# 05

## Comments and Responses – Railway Corridor

G:\4123742\GIS\Maps\MXD\100\_Planning\41-23742\_108\_rev\_b.mxd

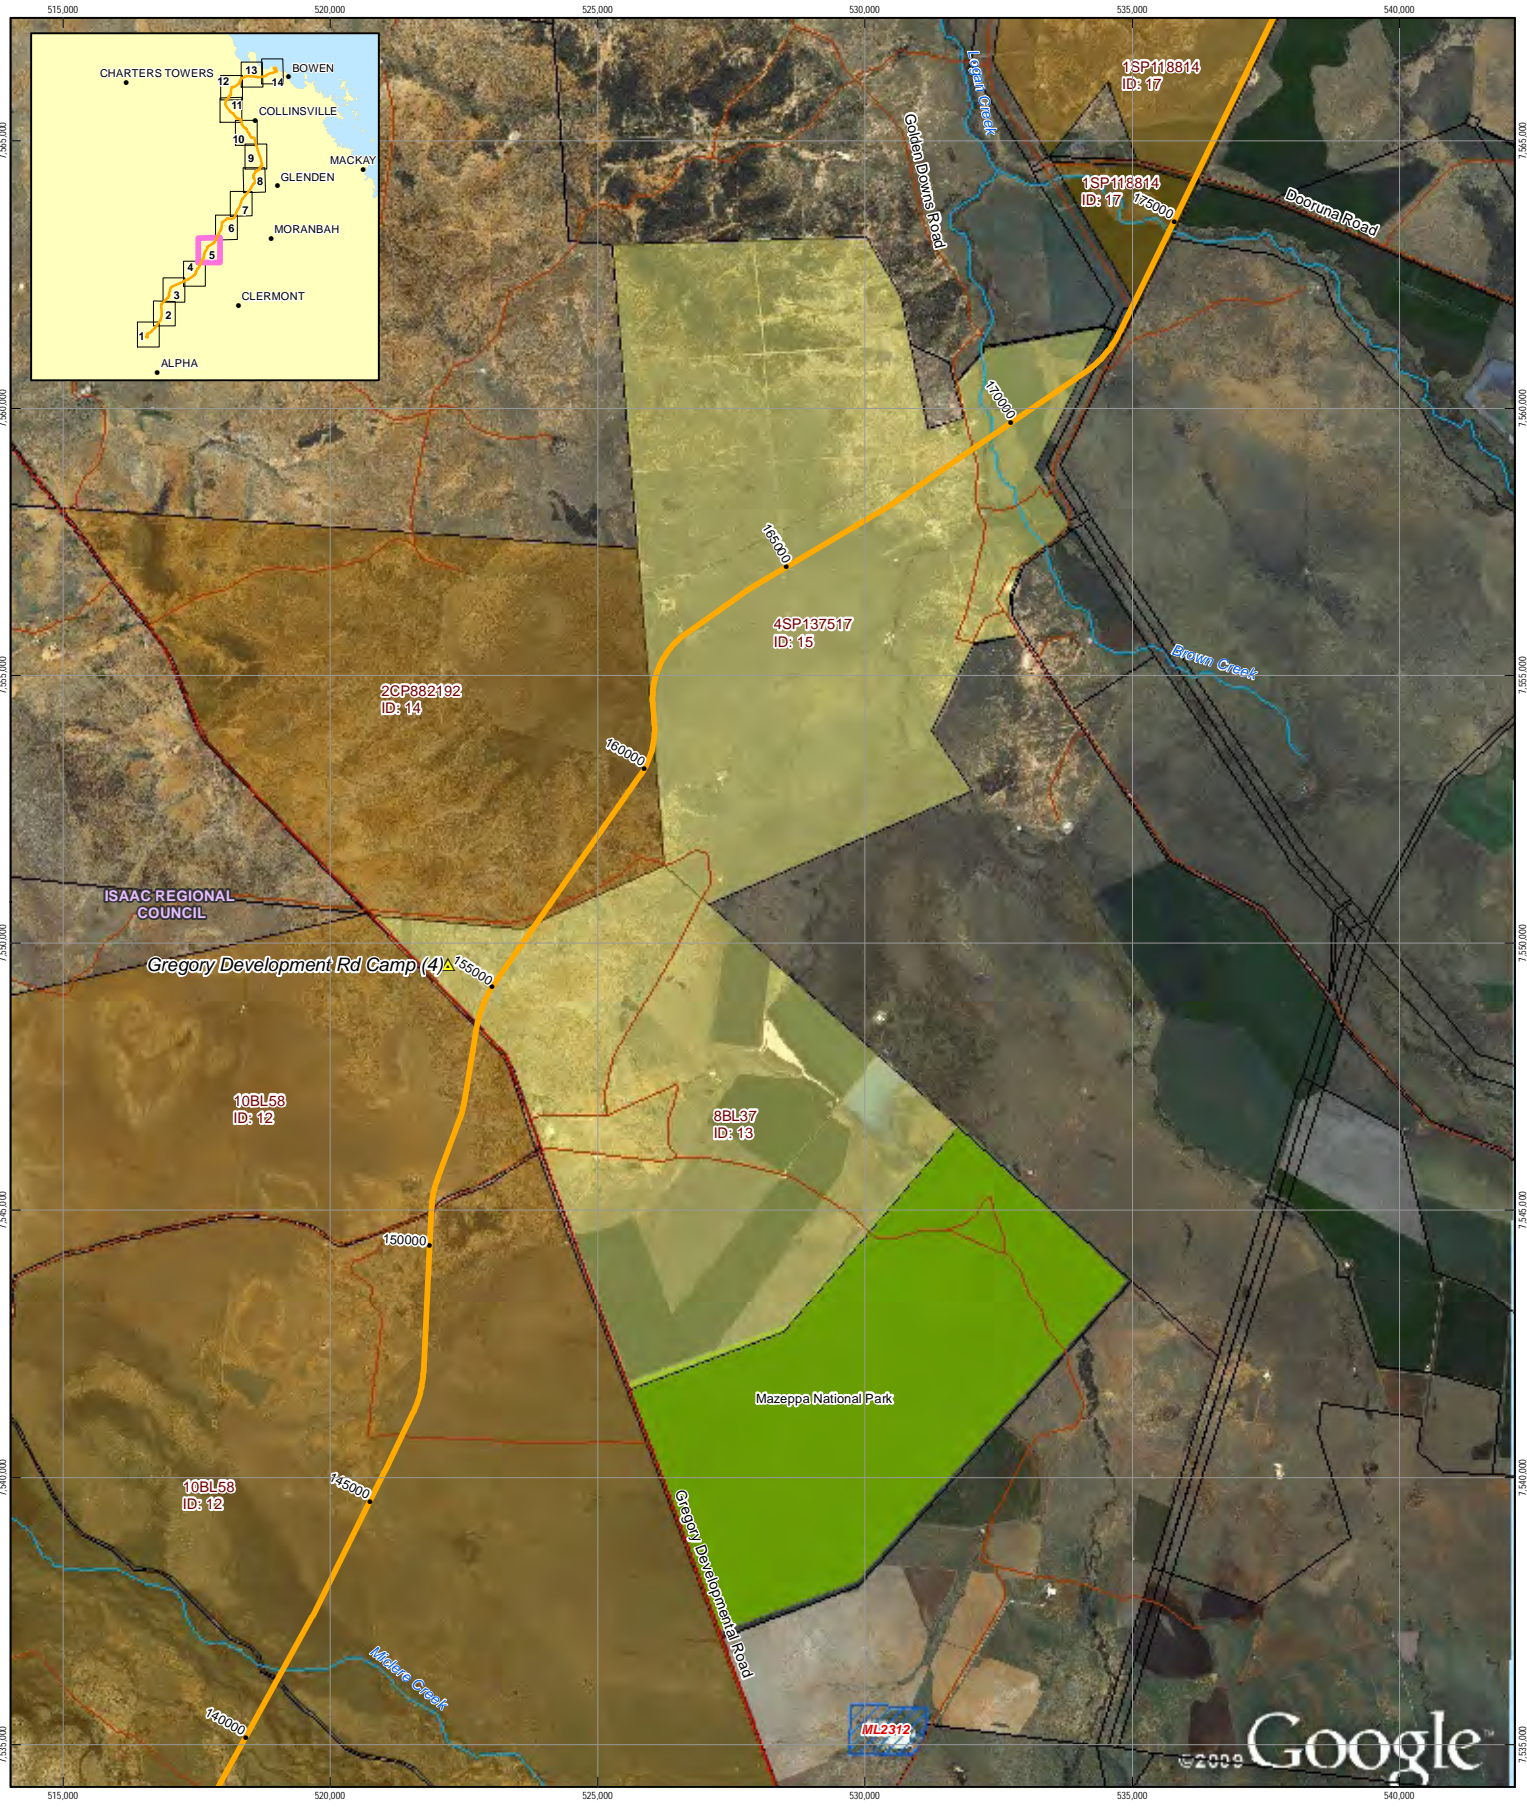
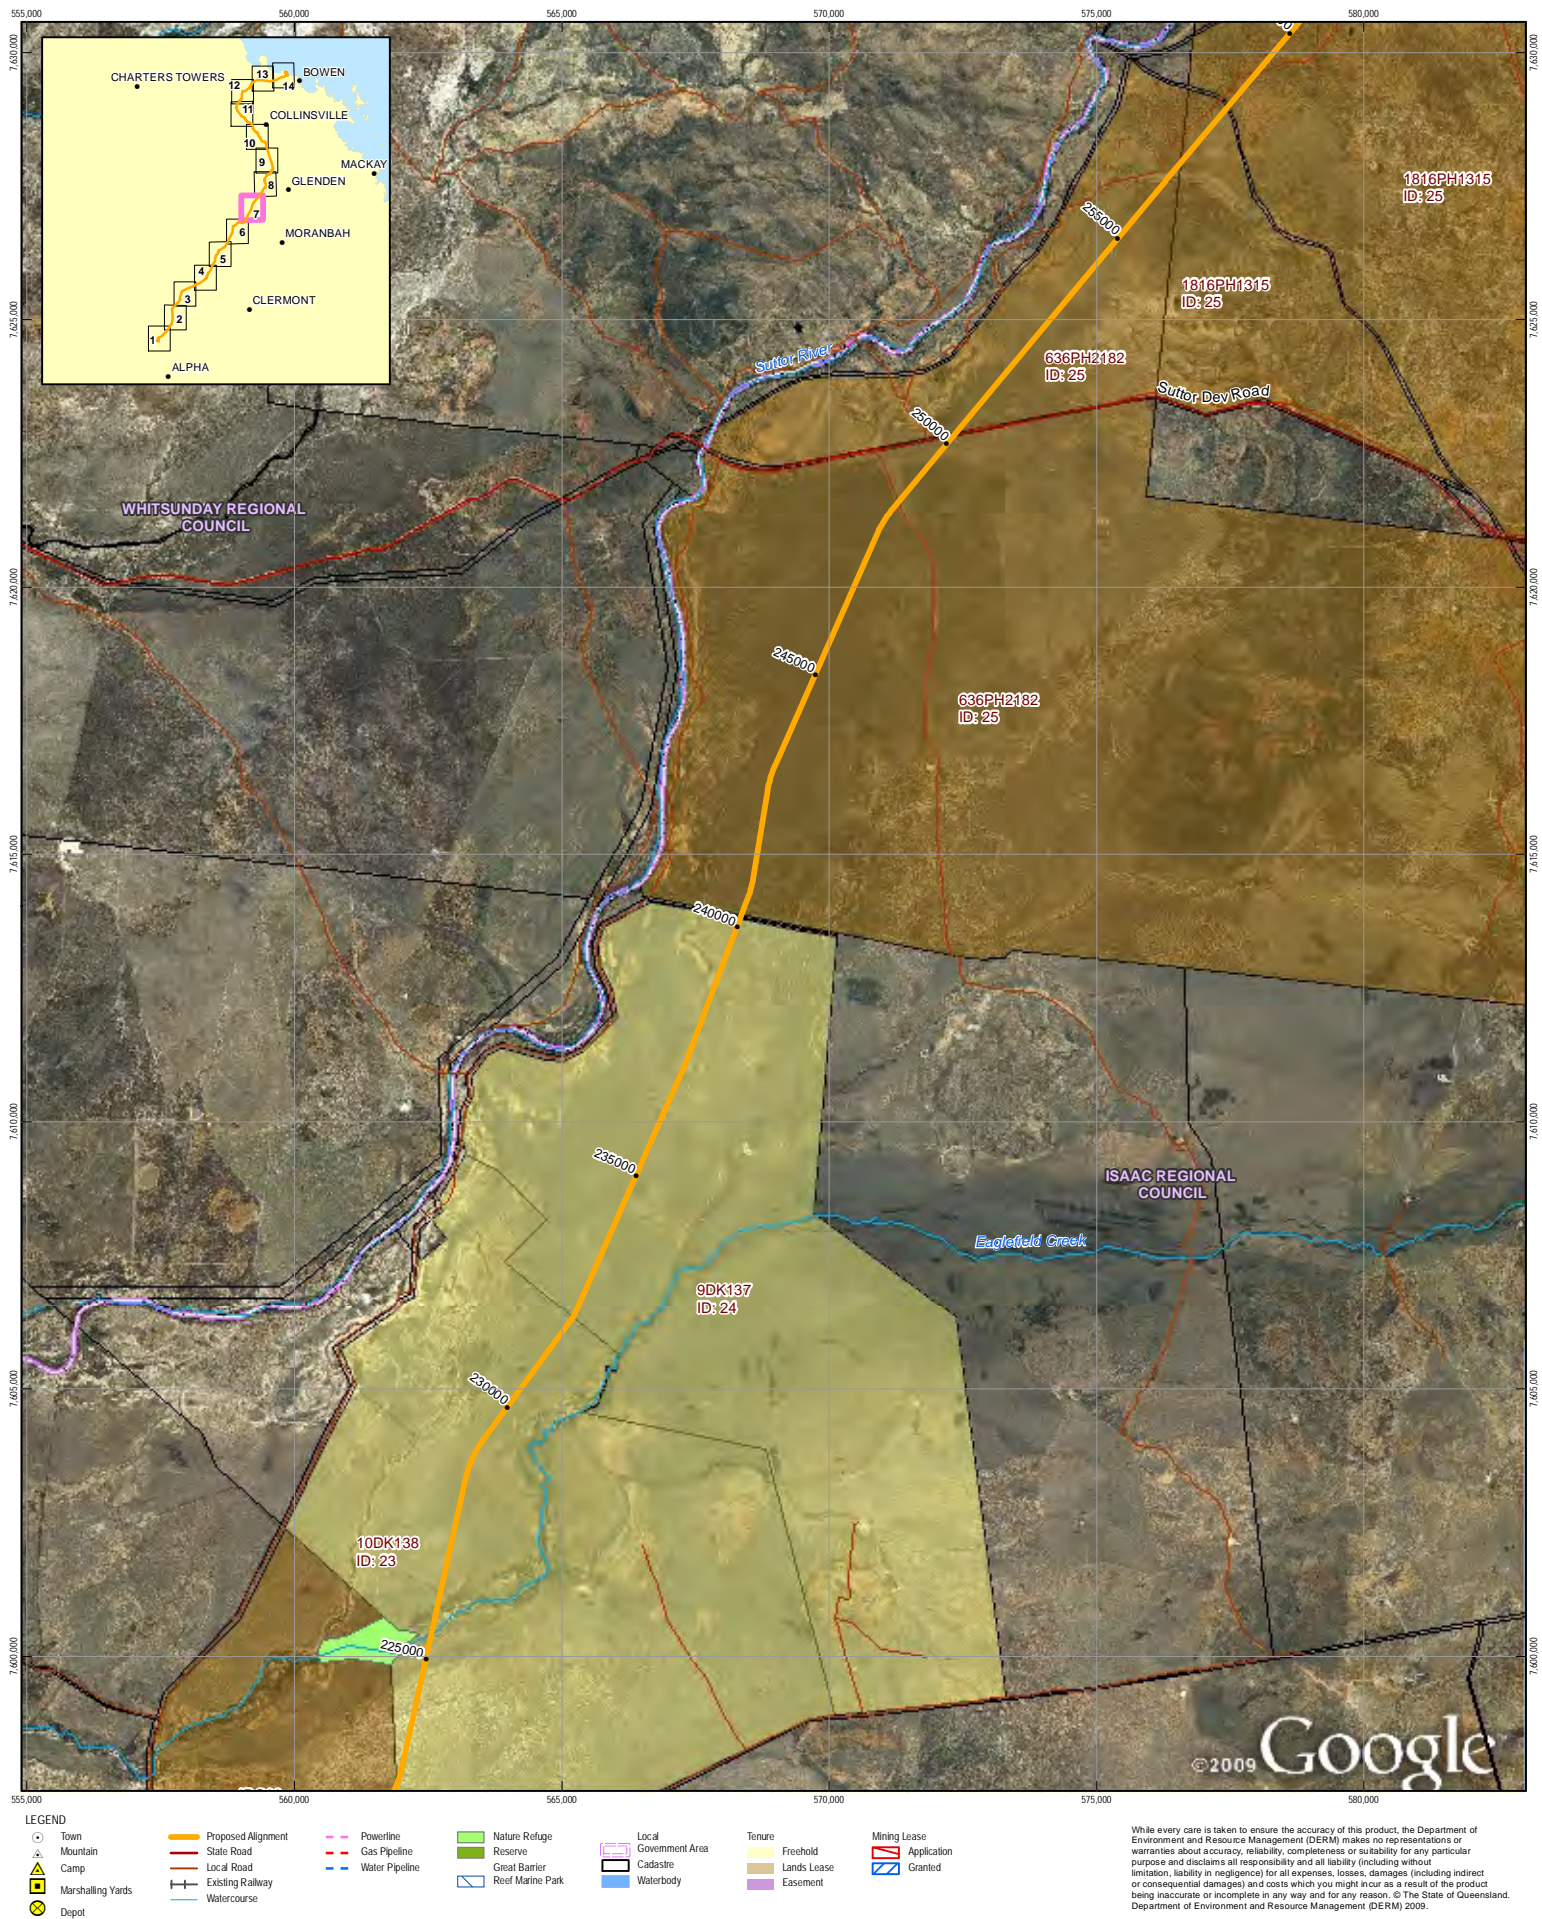
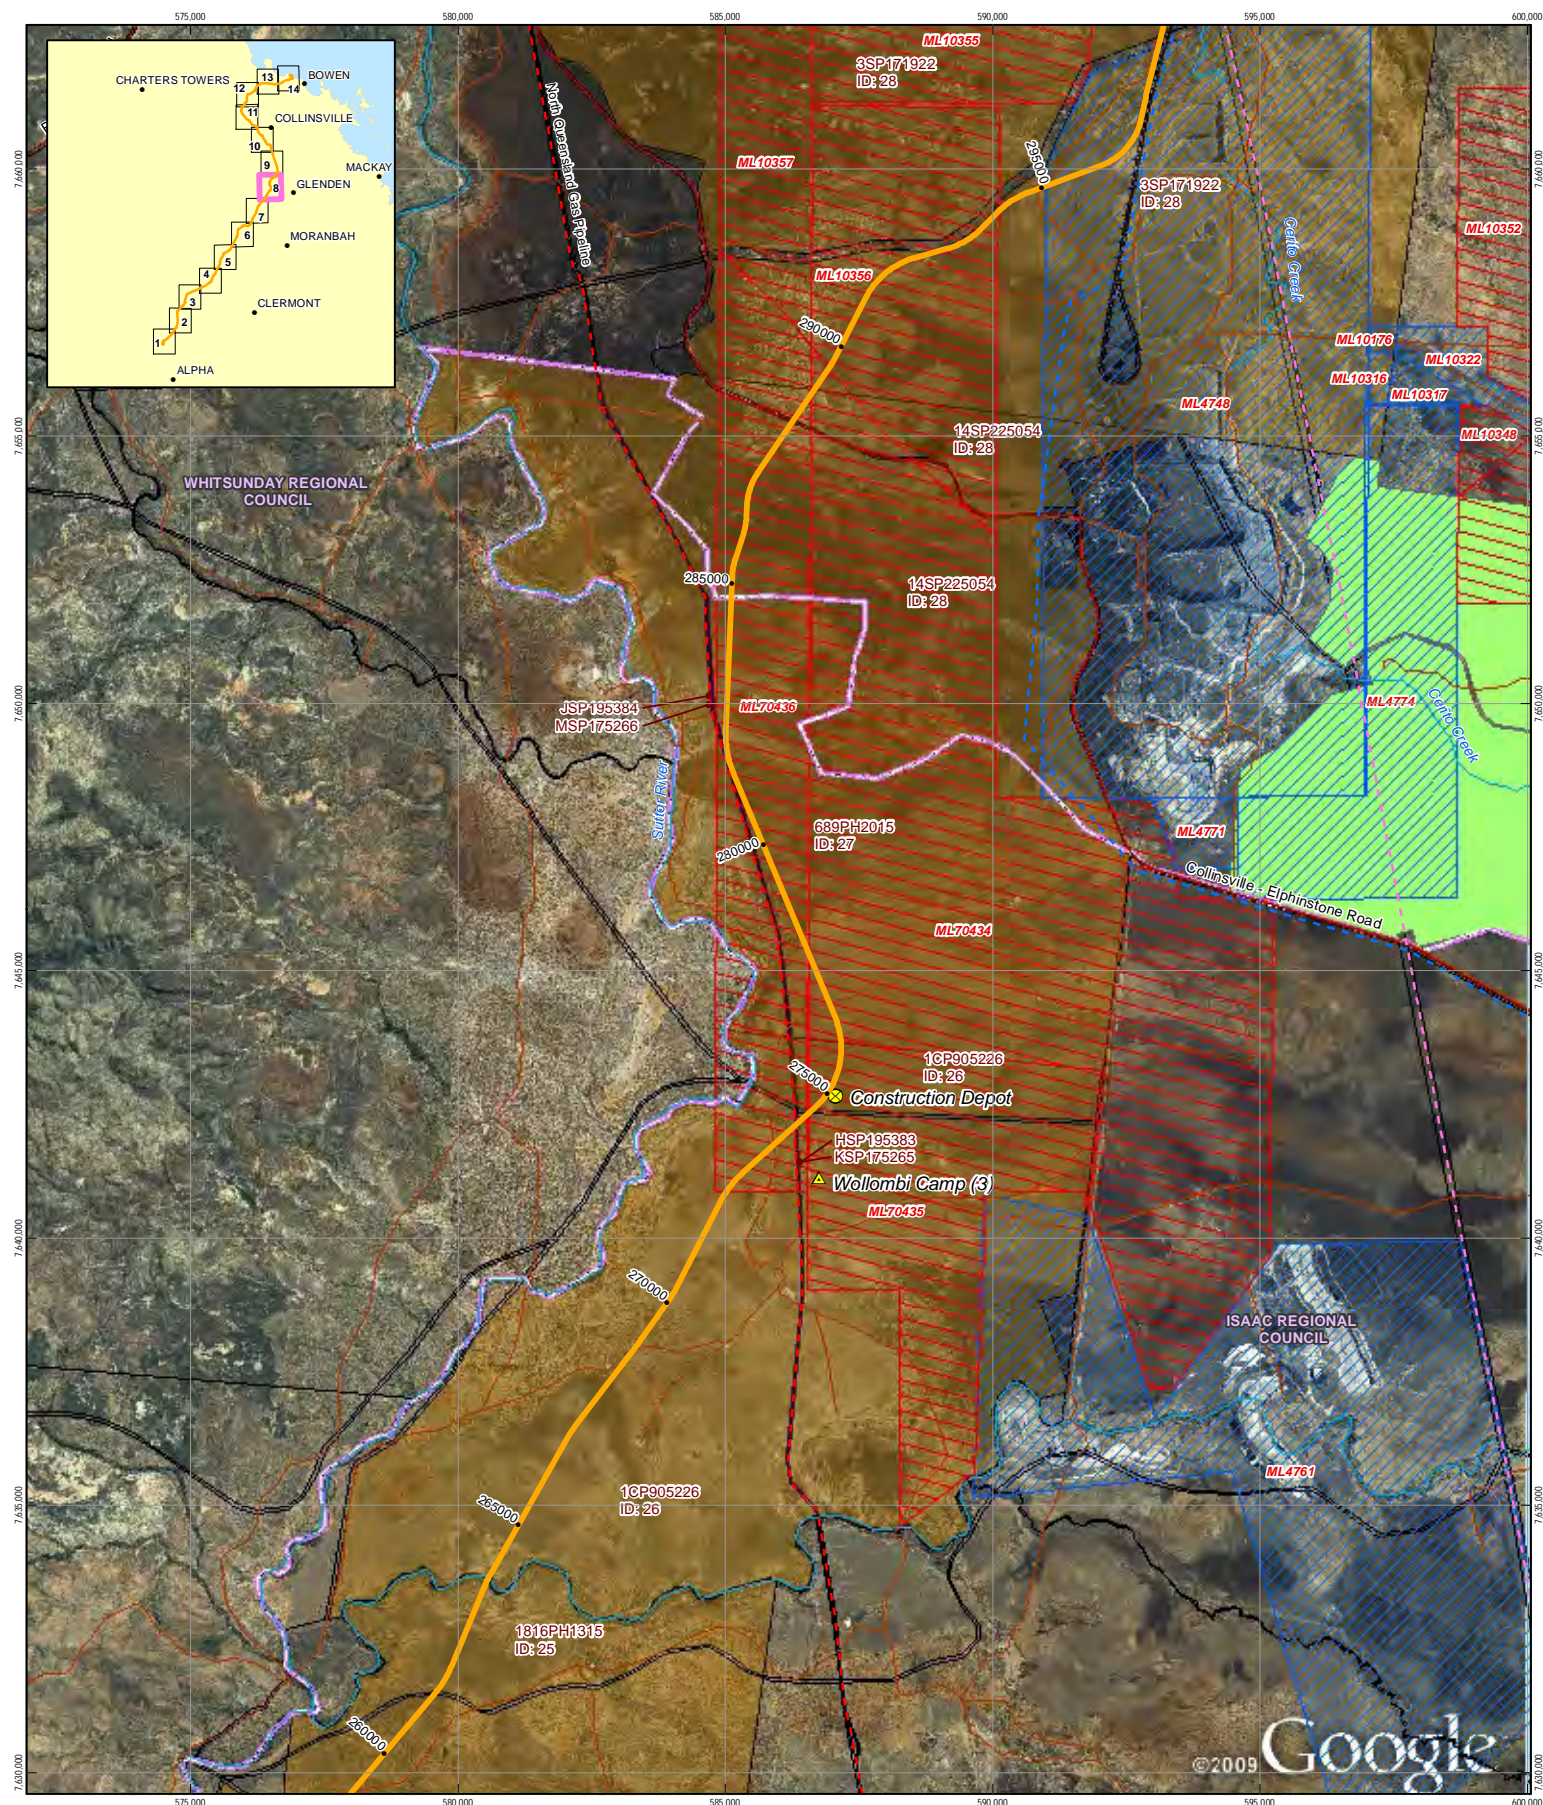
**5.23.5 Land use and Tenure****Comment – RC402**

*The proponent must describe all mining activities and mining tenures along the proposed railway corridor in this section of the EIS (existing environment).*

All mining activities are demonstrated in updated in Figure 5-2 below.
